**CLARKE COUNTY PLANNING COMMISSION
TABLE OF CONTENTS
December 2, 2022 Business Meeting Packet**

SPECIAL USE PERMIT & SITE DEVELOPMENT PLAN (SUP-22-03 / SP-22-04)

STAFF REPORT– Department of Planning

The two illustrations on the following page (copies of landscaping plan) show a layout of the phase 2 solar panels on the previously approved site plan and the proposed site plan. A copy of the Staff report from 2017 is attached for additional reference and comparison purposes.

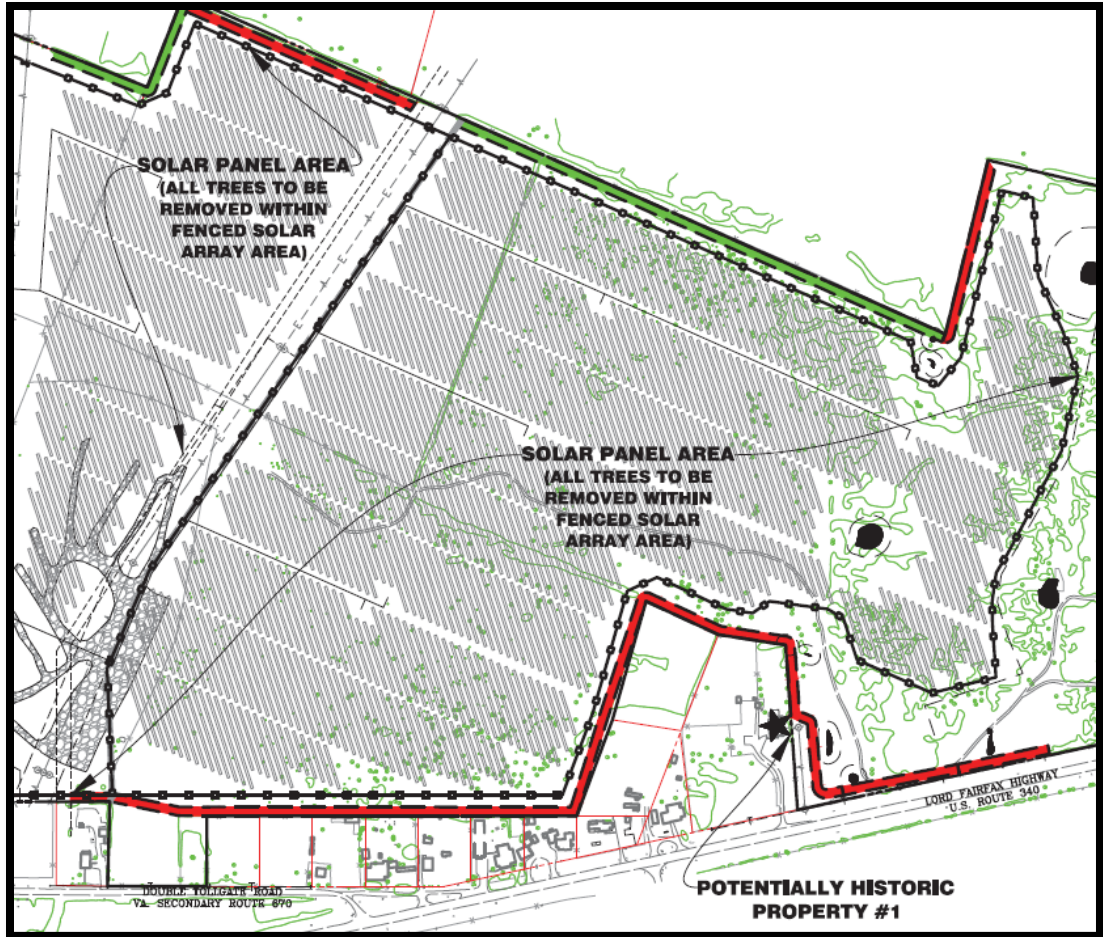
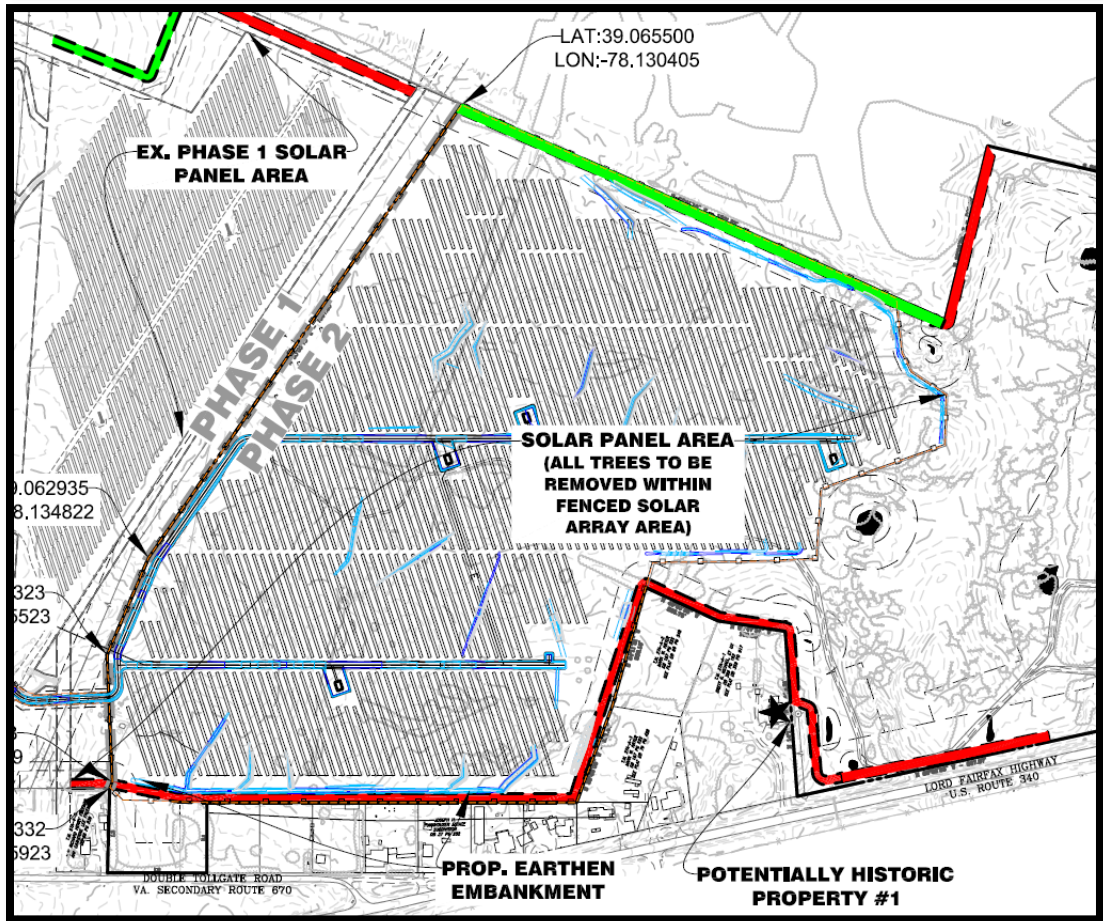
The same vegetative buffer design that was previously approved is being resubmitted with this application. Members of the Planning Commission recommended to the Applicant that the fencing and screening be modified adjacent to the houses that are along Double Tollgate Road so the property owners will view the trees instead of the fencing. The Applicant has not provided a response to this request at this time.

The Applicant has not provided a response to-date regarding the request made by Planning Commissioners that they consider placing the buffering trees on the side facing the neighboring houses, instead of having the fence facing the homes.
